PLANNING COMMISSION MEETING

A. **Oakland Harvesters**
Location: located on the north side of White Lake Road, west of Old White Lake Road. Identified as parcel 12-01-127-001, consisting of 2 acres. Currently zoned (LM) Light Manufacturing.
Request: **Final site plan approval**
Applicant: Oakland Harvesters
840 Sherbrooke St
Commerce Township, MI 48382

RE: Oakland Weed Harvesters -Final Site Plan Review- 1st Review

RE: Oakland Harvesters
Final site plan – Review #1

SOIL EROSION CONTROL & DISRUPTION PLAN
PARCEL NO. 12-01-127-001
WHITE LAKE TOWNSHIP, OAKLAND COUNTY, MICHIGAN

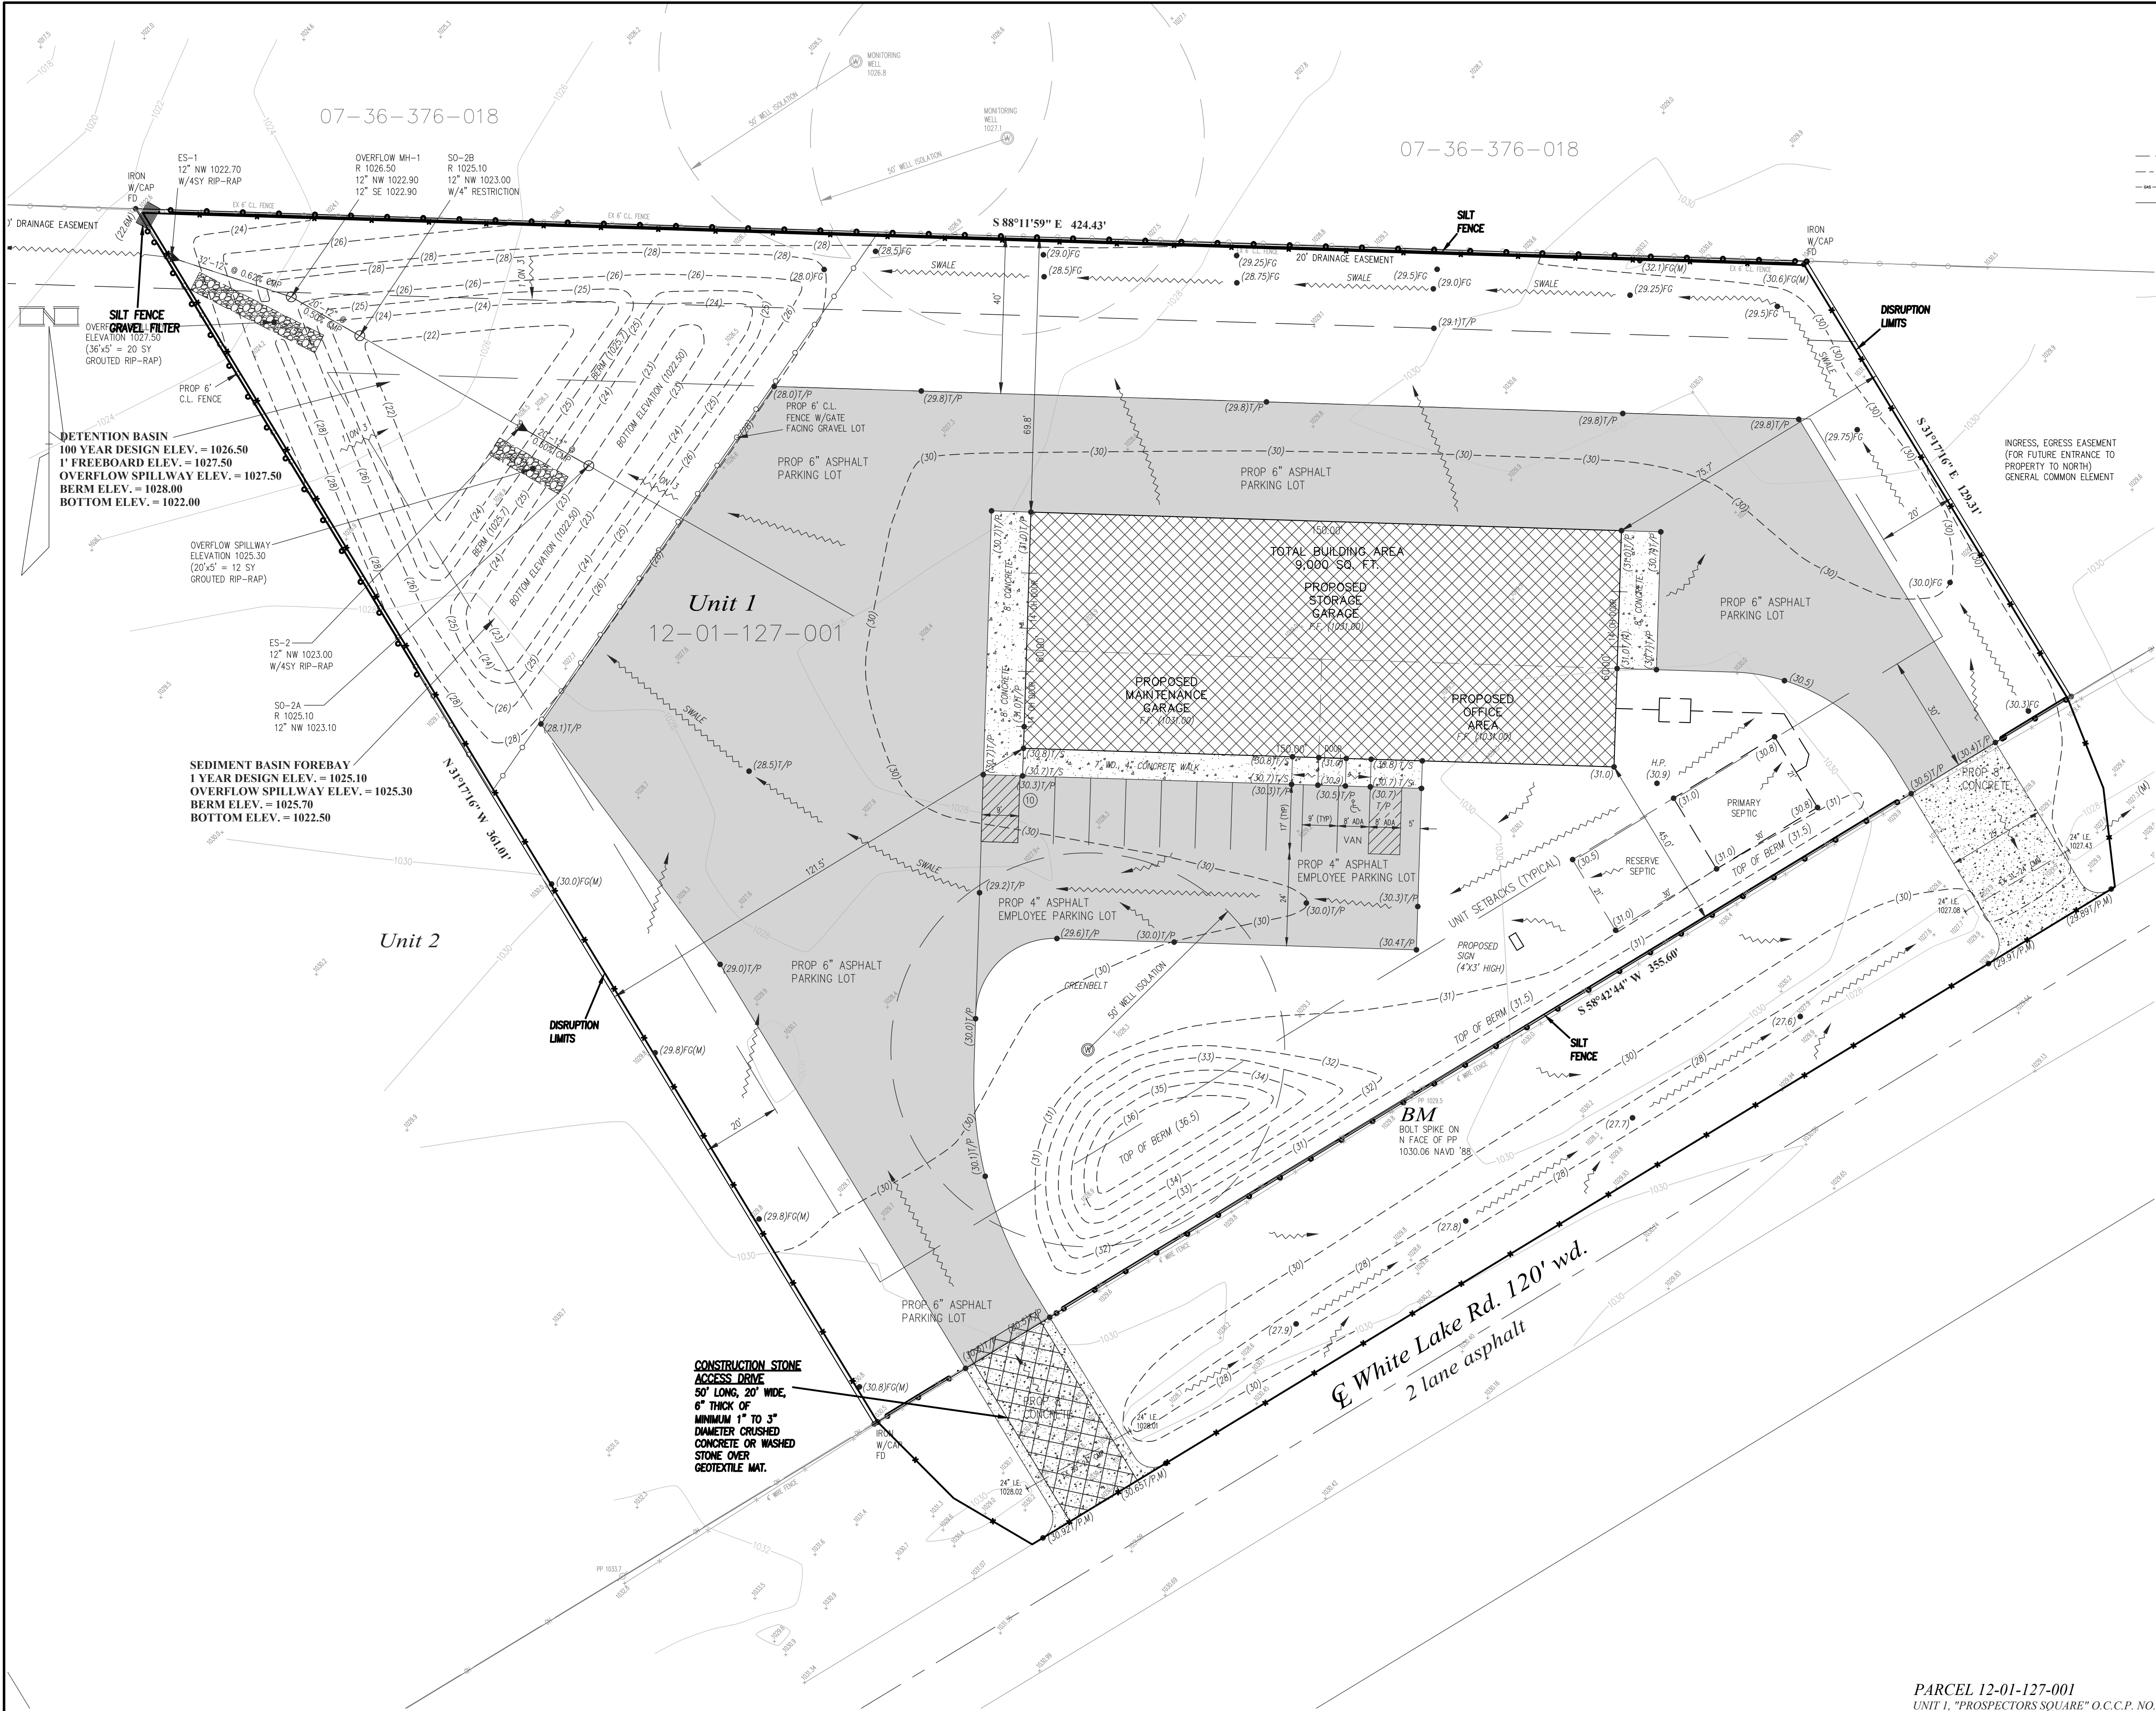
The Construction/Soil Erosion Sequence on Sheet C-4 shall be revised to address the following:

- A gravel lot is not proposed – revise B and E accordingly.
- No storm sewer system is proposed – revise D and H accordingly.
- Sod is required in certain places – revise I accordingly.

DRAWING TITLE:
ENLARGED OFFICE PLAN

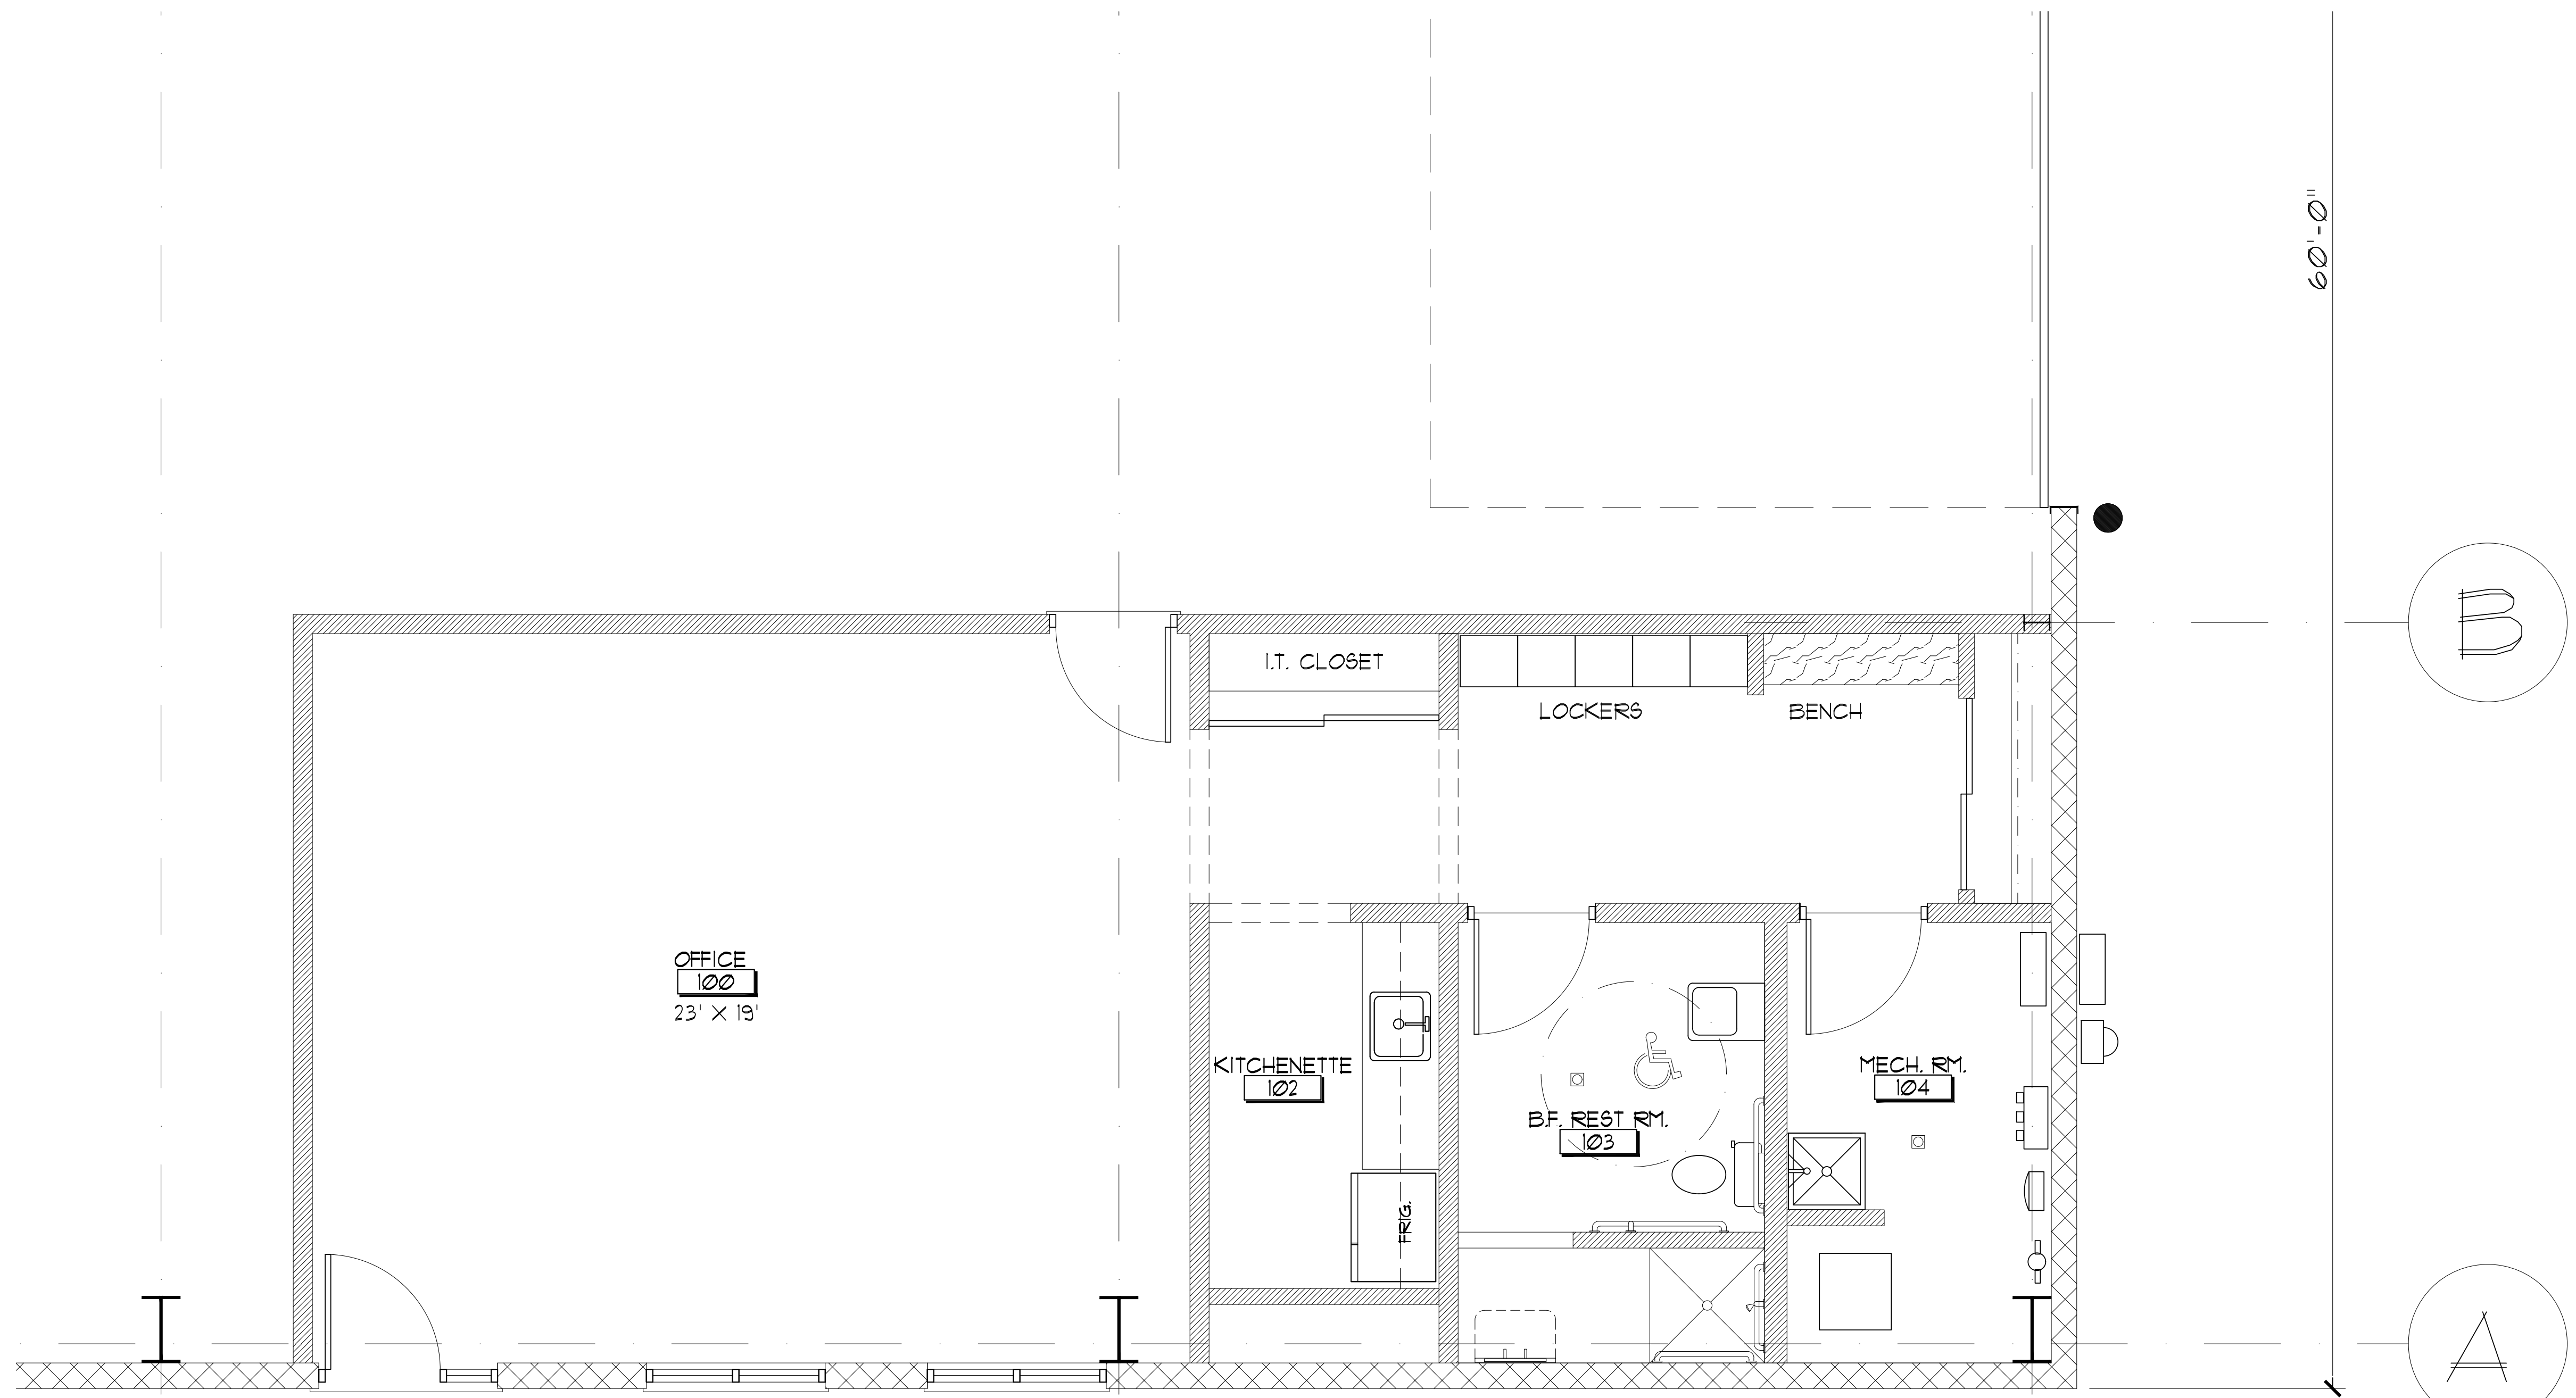
- The Drawing Title on Sheet A-3 shall be revised. Sheet A-3 is not the Enlarged Office Plan, but an Elevations sheet.
- On Sheet A-3, the front elevation shall be identified as the south elevation and the rear elevation shall be identified as the north elevation.

DRAWING TITLE:
Elevations

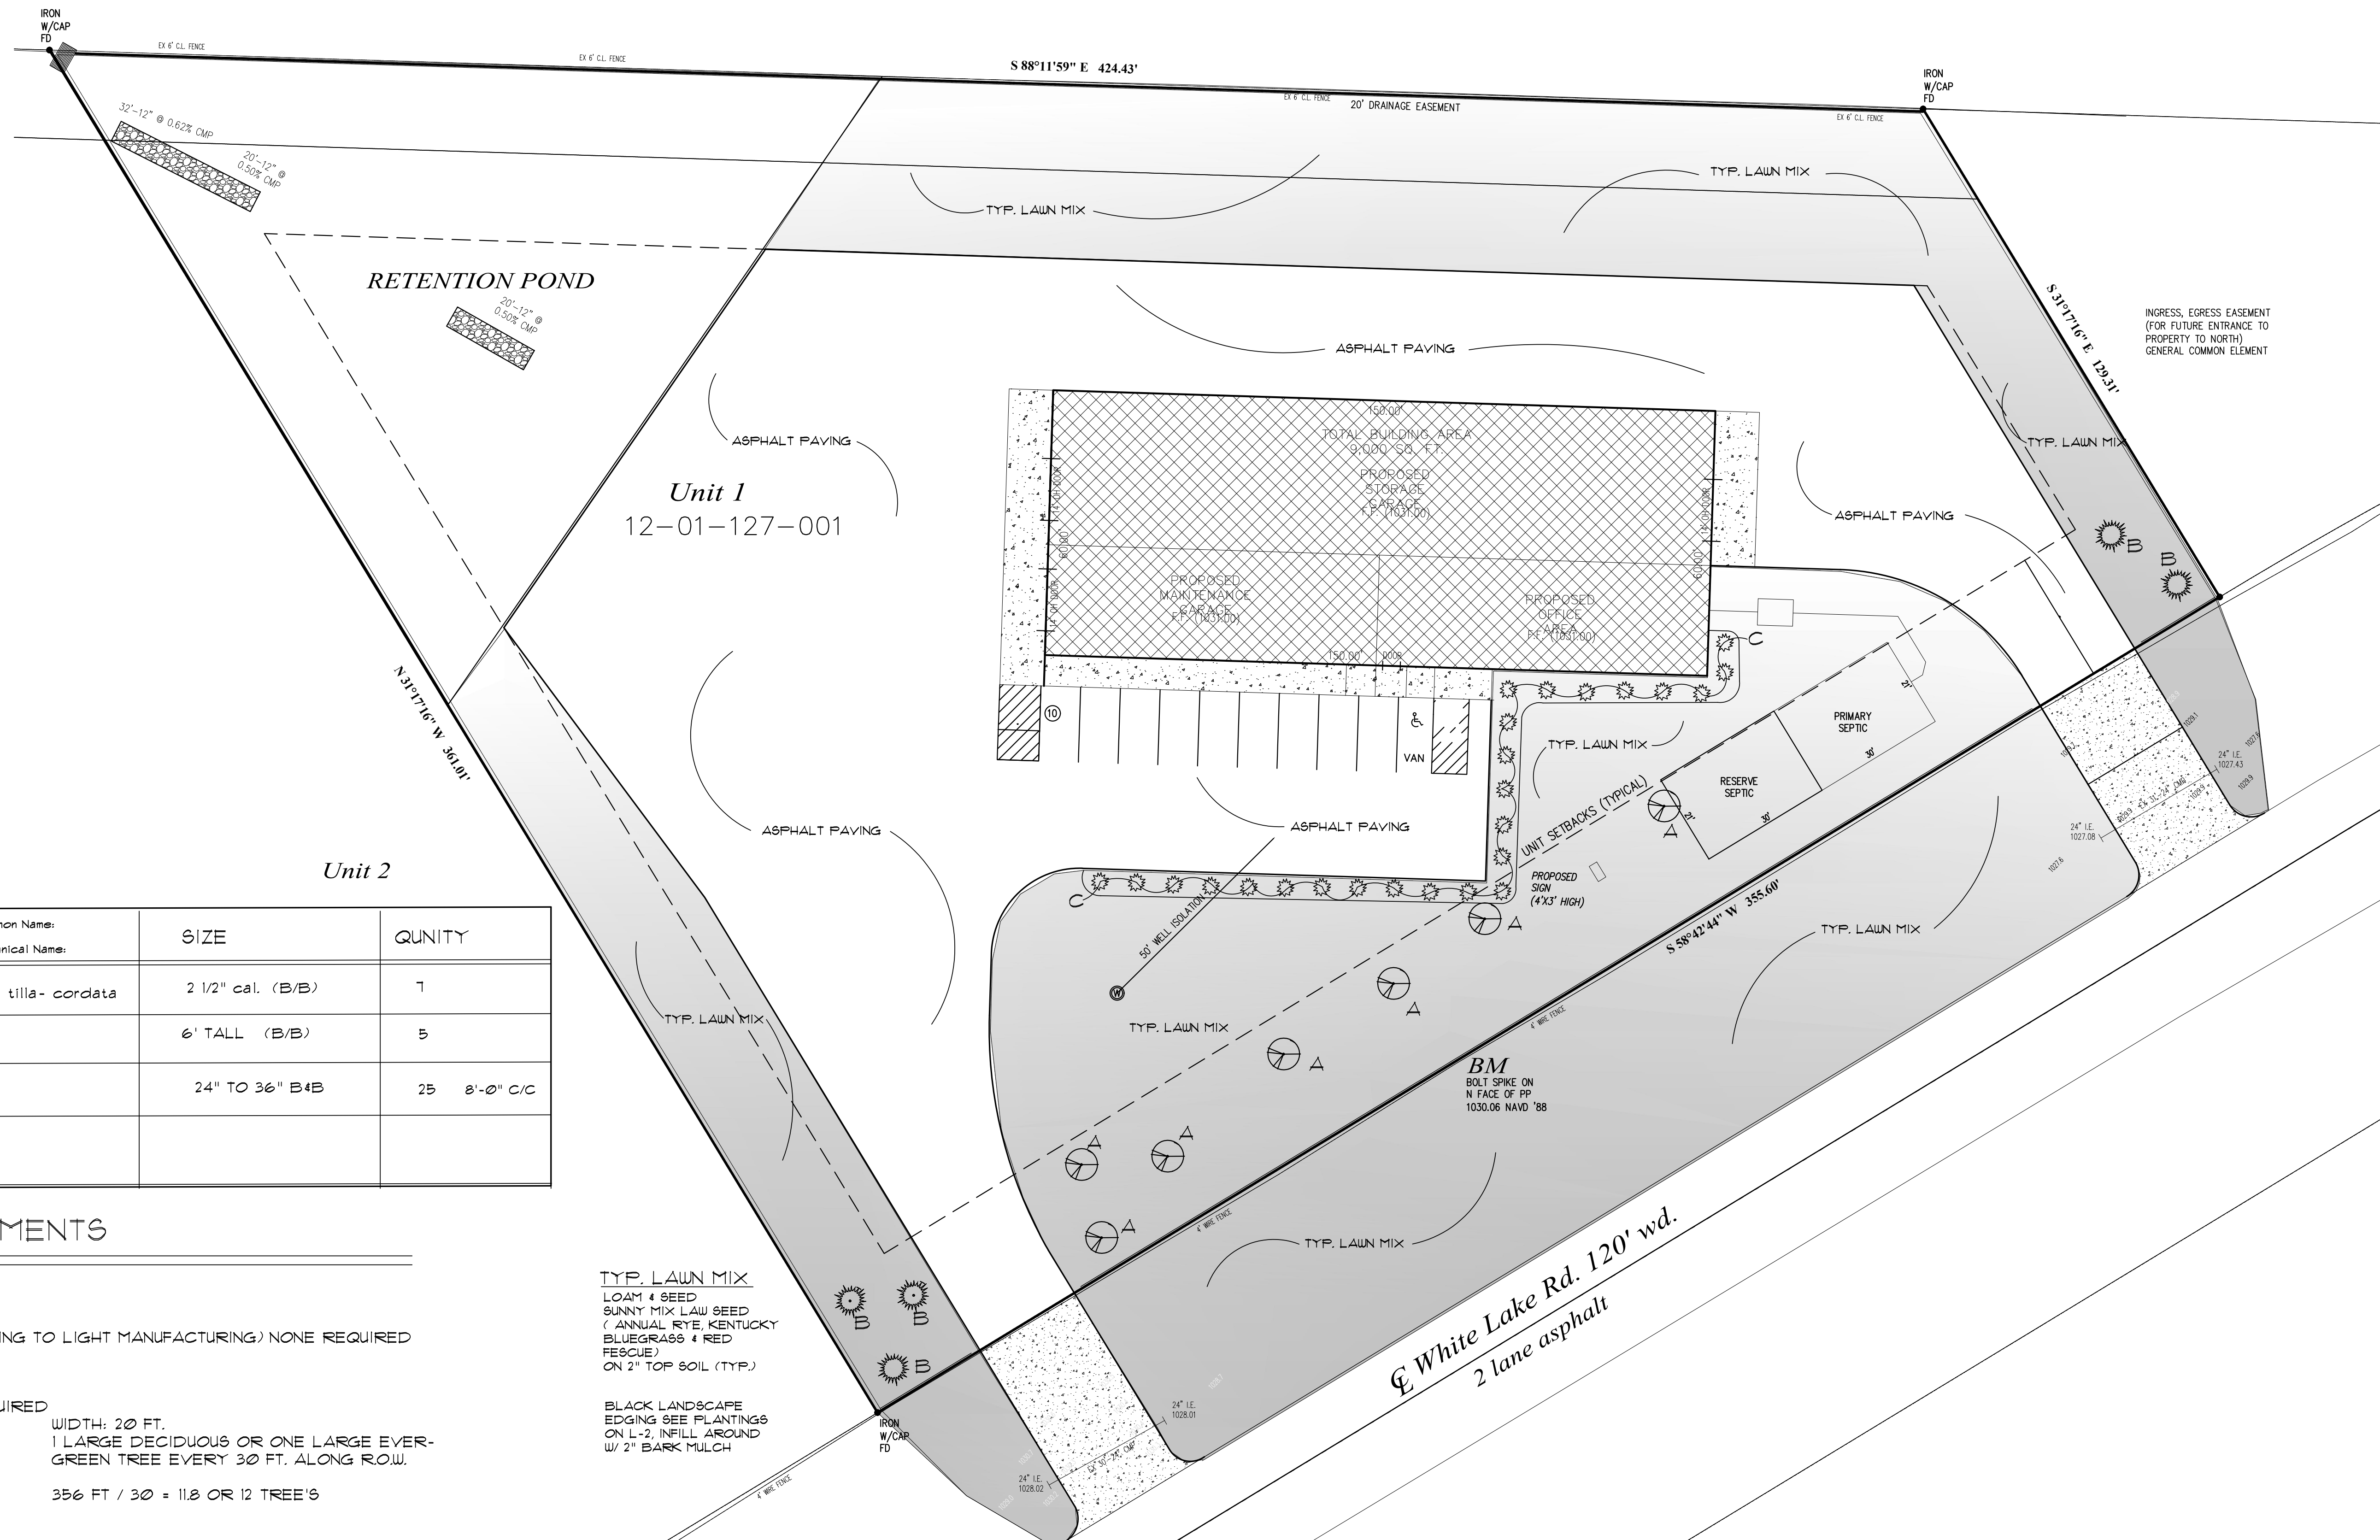
- On Sheet A-4, the south elevation shall be identified as the east elevation.
- The following revisions to the Material Schedule on Sheet A-4 shall be made:

- Replace the word “corrigated” with the word “corrugated” in Number 1.
 - Number 8 references downspouts directing water to a storm drain system. There is no proposed underground drain system to control stormwater. As the means of stormwater management, the applicant is proposing to use sheet drainage across the parking lot to surrounding vegetated areas/swales. A sediment forebay will receive stormwater prior to entering a detention basin. The reference to storm drain system shall be removed.

- Replace the word “ballard” with the word “bollard” in Number 11.
 - Replace the word “high” with the word “grade” in Number 11.
 - Remove Number 13 and Revise Numbers 14 and 15 accordingly. Wall pack lighting shall not be shown on the elevations. The photometric plan is utilized for outdoor lighting. Currently, the elevations and photometric plan show a differing number of wall packs on the building.
